**82-90 Christie Street, St. Leonards**

Please find herein a review of the Windtech report entitled 'Pedestrian wind environment study 88 Christie Street, St. Leonards' dated 13 December 2017, ('the Report').

Figure 1: Recommended test area from AWES (2104)

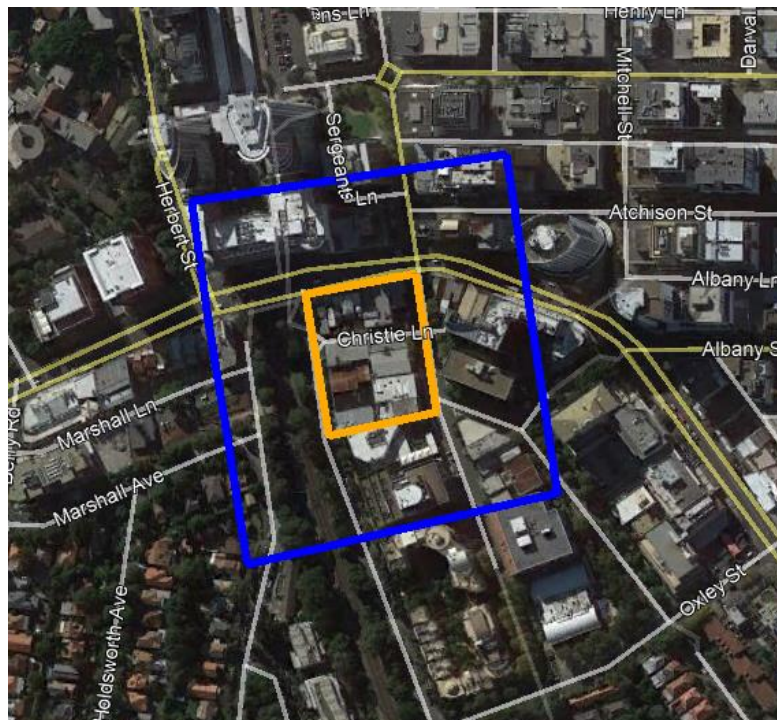
The test area considered for the assessment is not considered great enough to capture the impact of the proposed development. The recommended assessment zone is shown in Figure 1. Such a large development would be expected to have a greater impact on the surrounding environment further from the site than the area tested, particularly on the south-west corner of the intersection of Christie Street and the Pacific Highway. Figure 5k in the report showing the location of the remote test locations on an aerial photograph is poor to get an appreciate of the exact test location.

Figure 2: Test Locations 1 and 2 (L), and aerial image (R)

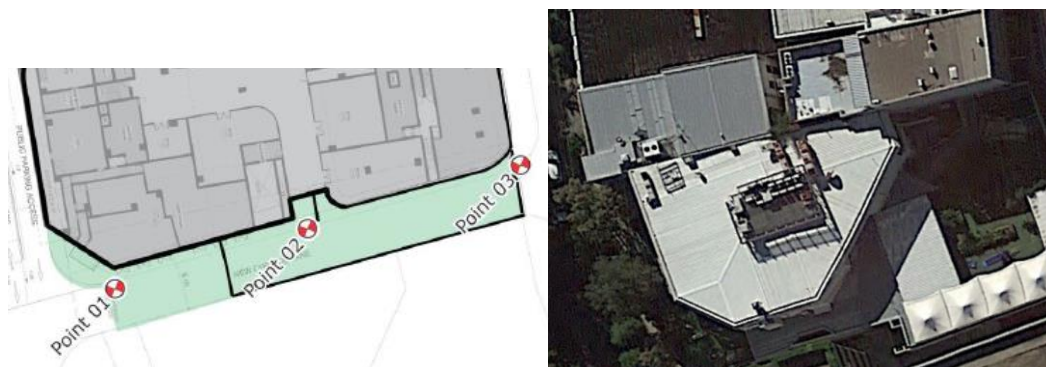
Locations 1 and 2 in the existing configuration would appear to be inside buildings, Figure 2. As there is no data for the existing configuration in the Report, it is impossible to check.

Figure 3: Comfort results from the Report for various positions on the ground plane

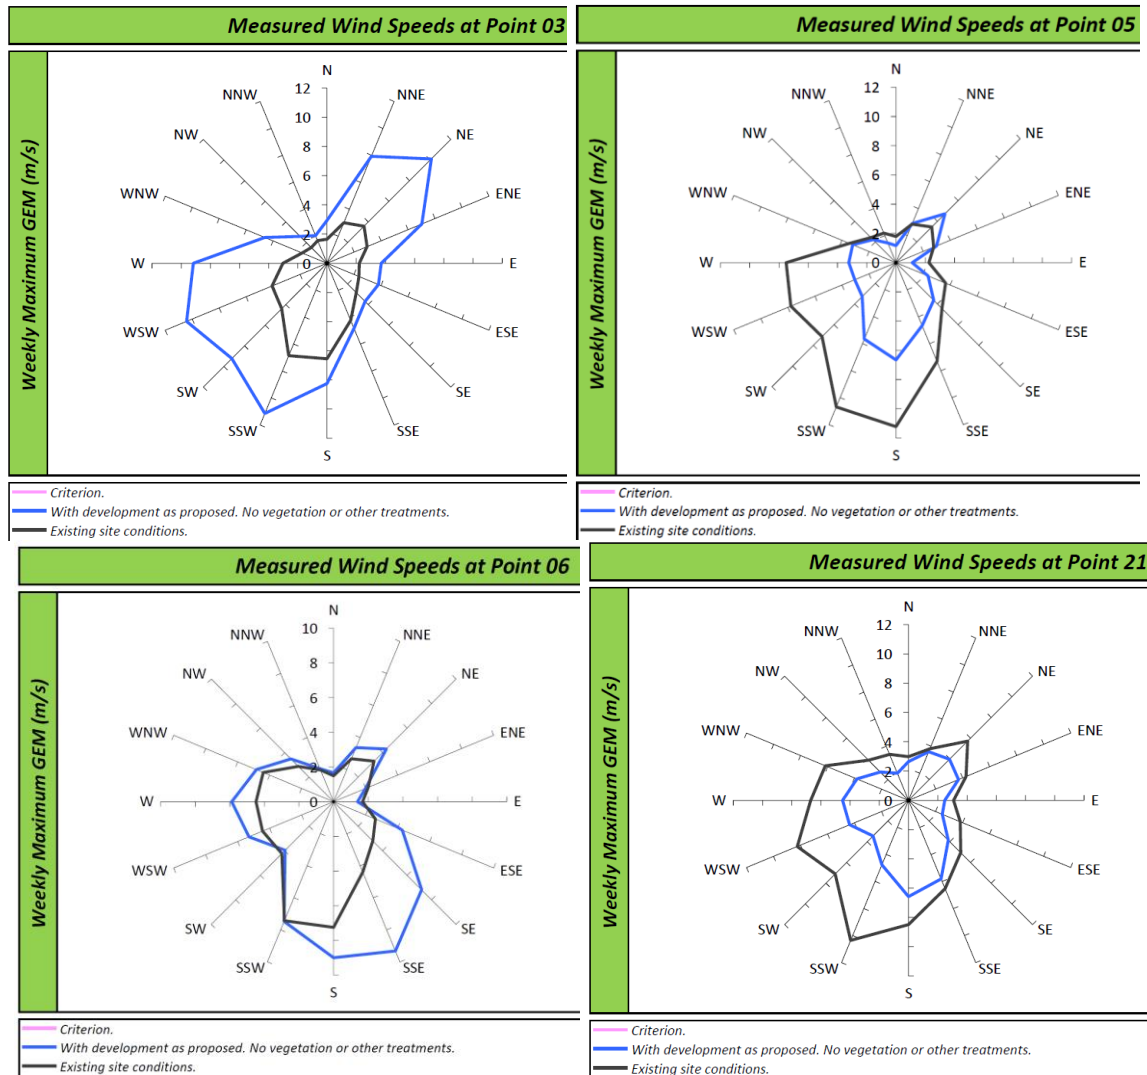
As there is insufficient detail in the report and no discussion around the results, there are some uncertainties as to the cause for some of the trends in the results. The inclusion of such large buildings on the fringe of a built-up area would be expected to have a significant impact on the local wind climate, particularly around the corners, such as Location 3, Figure 2, where the impact of the development has a significant impact on the wind conditions Figure 3. However, for example Locations 5, and 21, Figure 4, illustrate that the

proposed development offers significant protection from all wind directions. The change in measured mean wind speed between Locations 5 and 6 in the existing configuration for winds from the south goes from 7 to 11 m/s. This gradient of wind speed in a relatively benign area requires some level of explanation.
